AGENCY COORDINATION

Sample Early Coordination Letter

Subject: US 50 North Vernon Bypass—East
Designation # 1173374
Early Coordination Initiation
Jennings County, Indiana

Spill Containment System
Storm Detention Solution
30 min reaction time
AIT #1

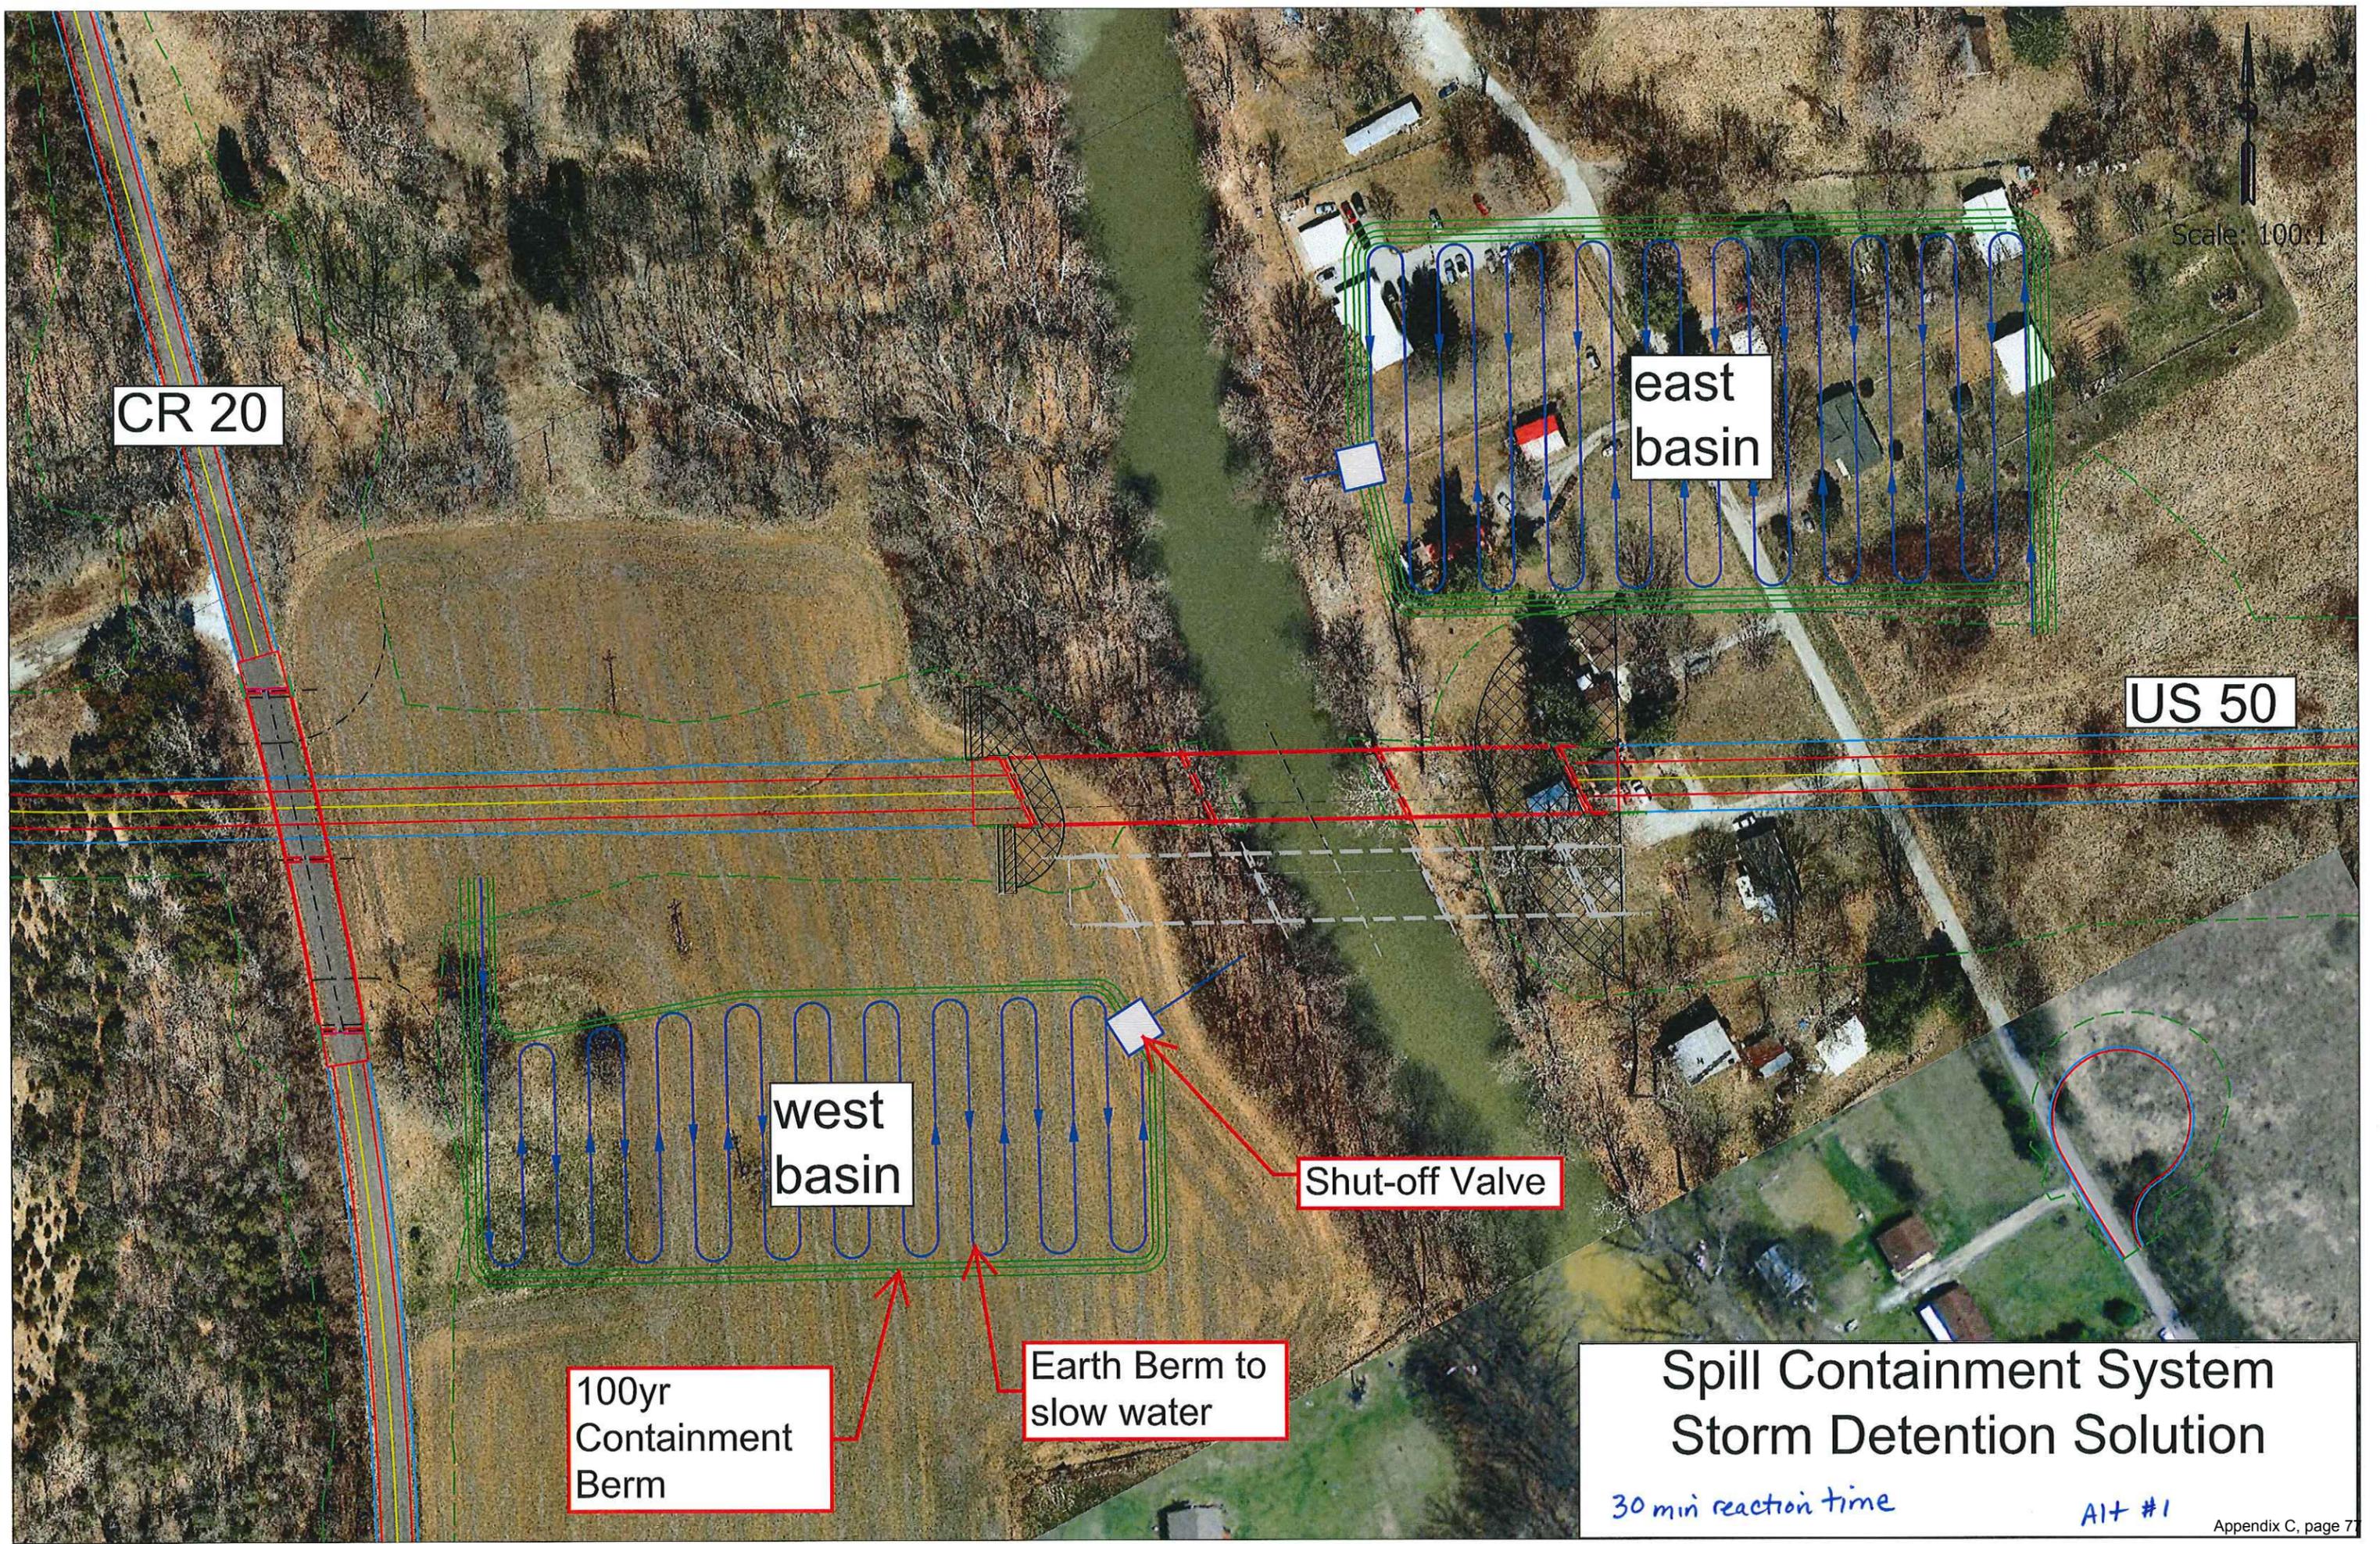
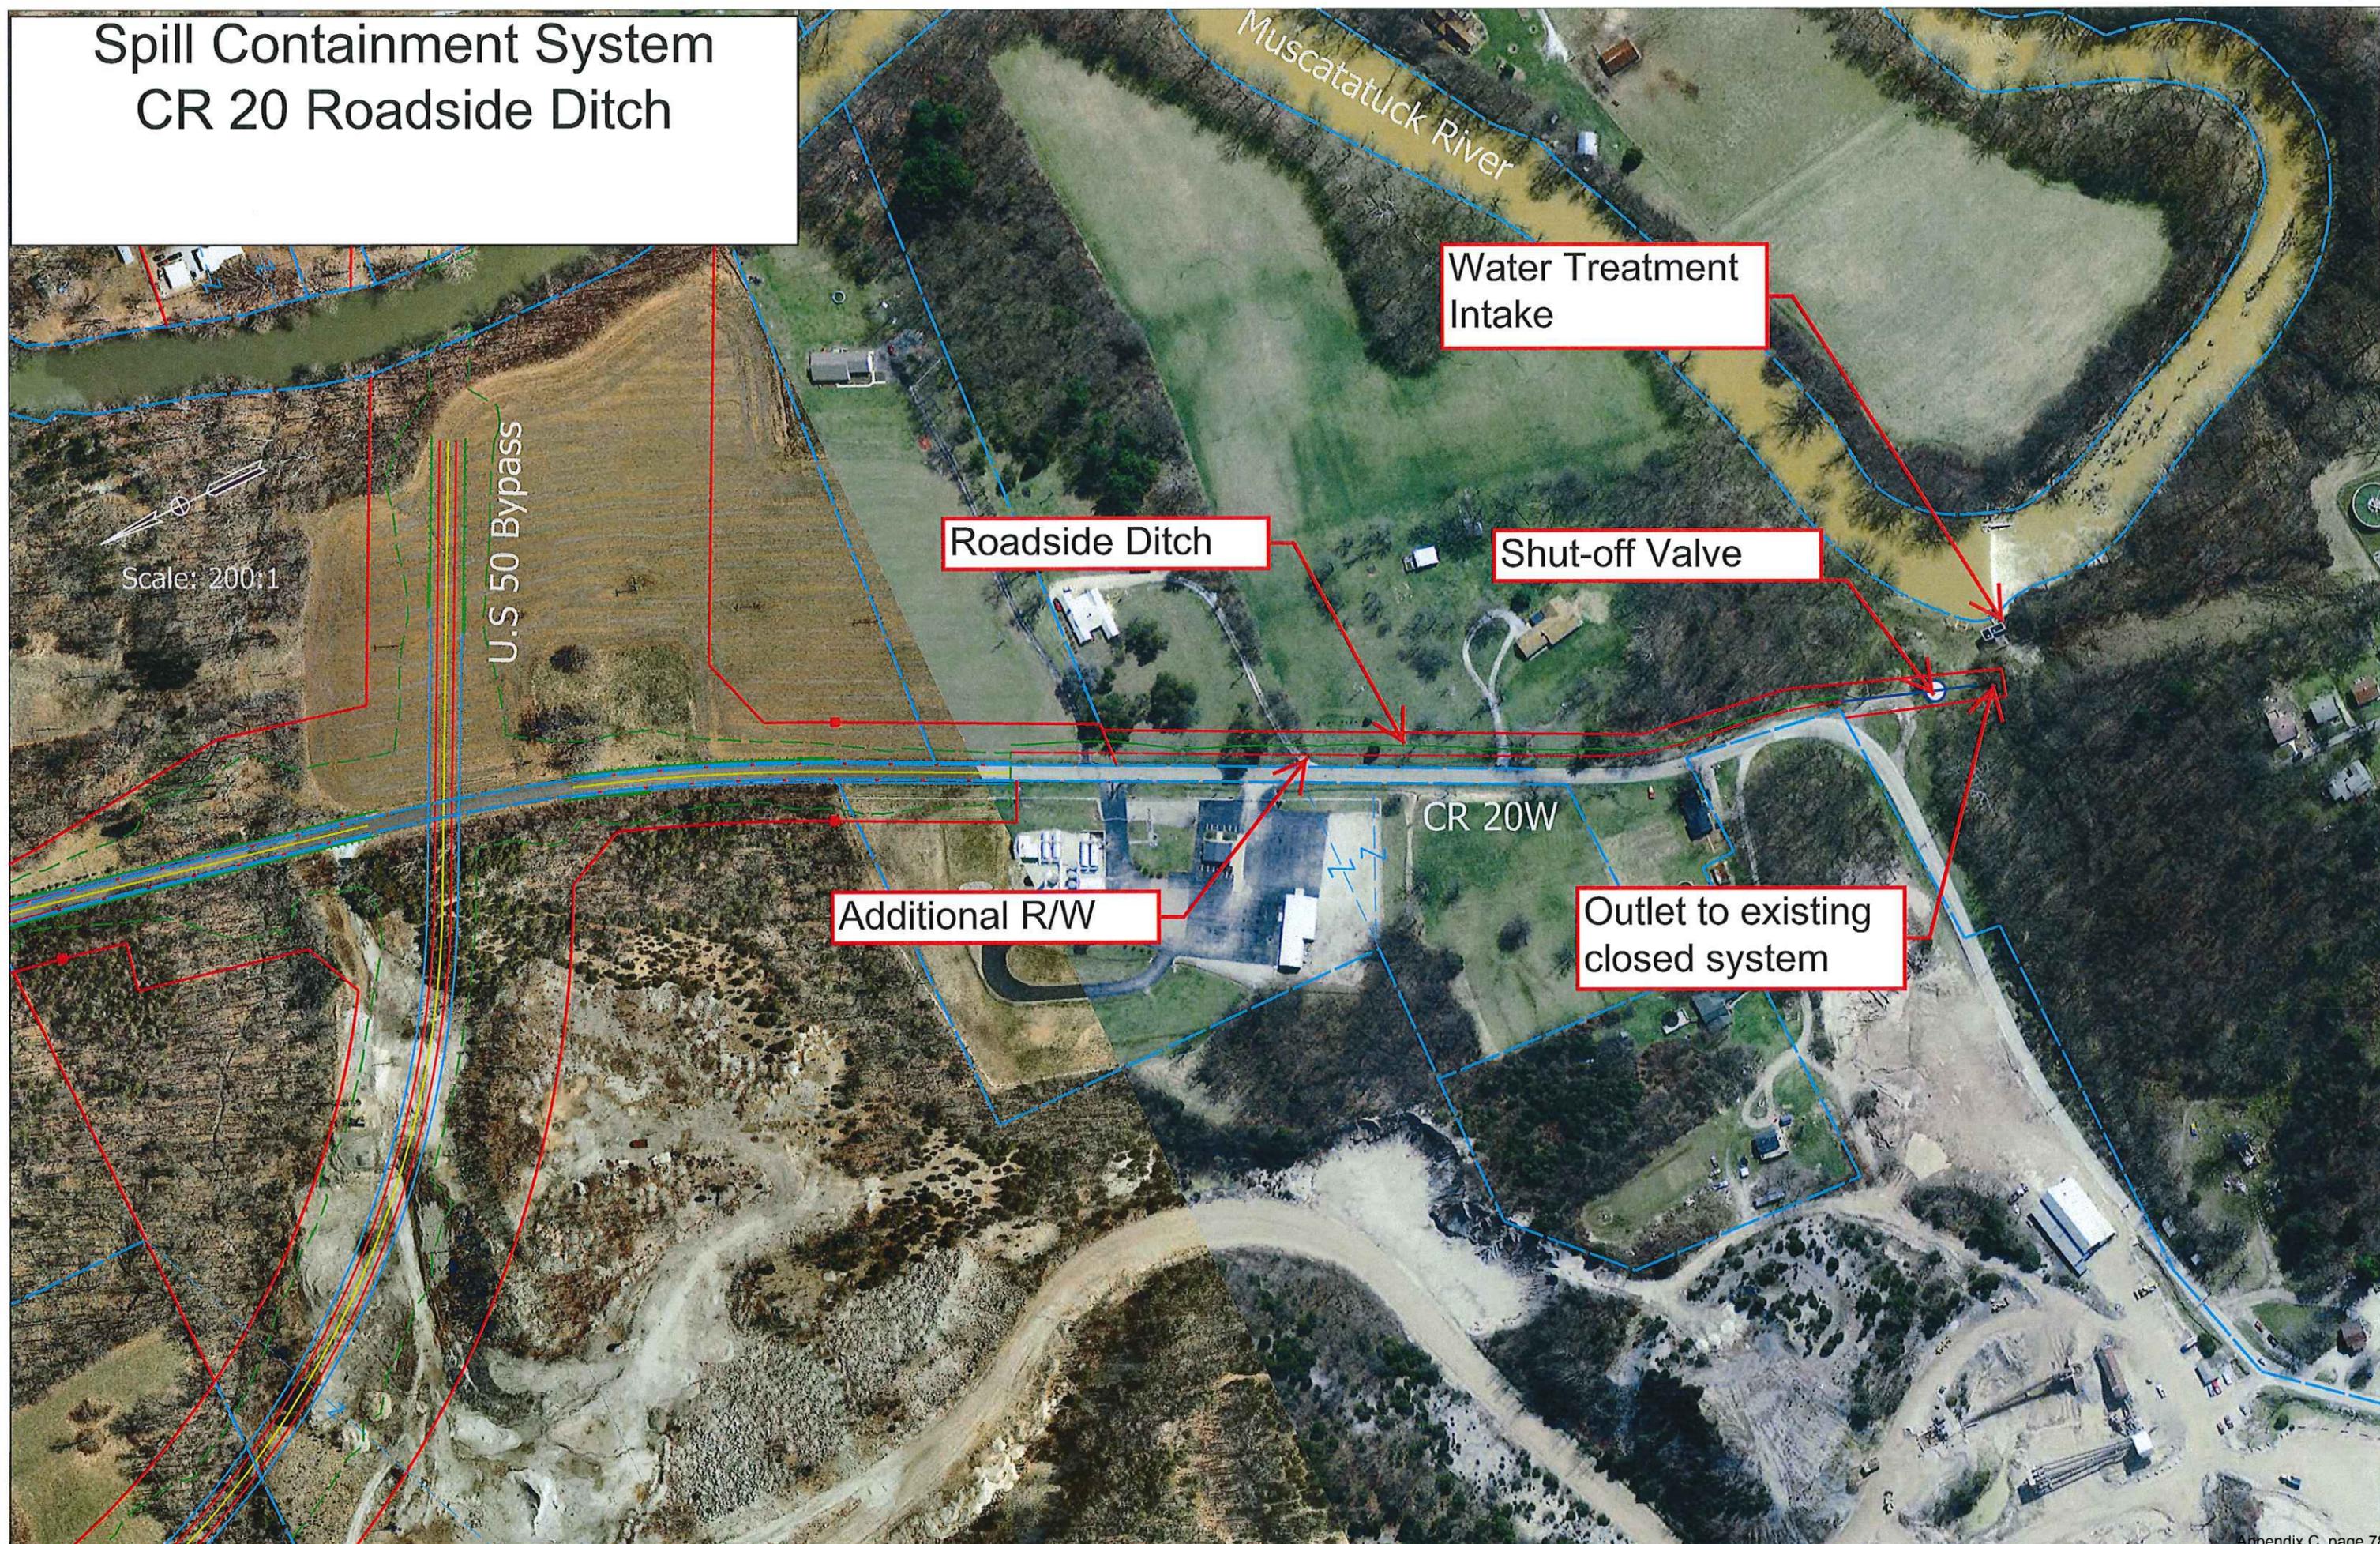
The safeguard techniques mentioned may be suitable for other areas in the watershed, but are less reliable at the impoundment. The use of these methods at other areas of watershed, such as a river location upstream of the impoundment or tributaries to the river above the low head dam may provide for some safeguard. At these locations, filters, containment dams, and absorption devices could provide a more reliable safeguard than directly at the impoundment.

- the added distance to the impoundment (and water intake structure),
- added dilution effect,
- allowing nature to assist in protection by adsorption or absorption, or treatment of the contaminant,
- allowing more time for personnel reaction to shut down the water supply, assess the situation, and further contain and remedy the contaminant.
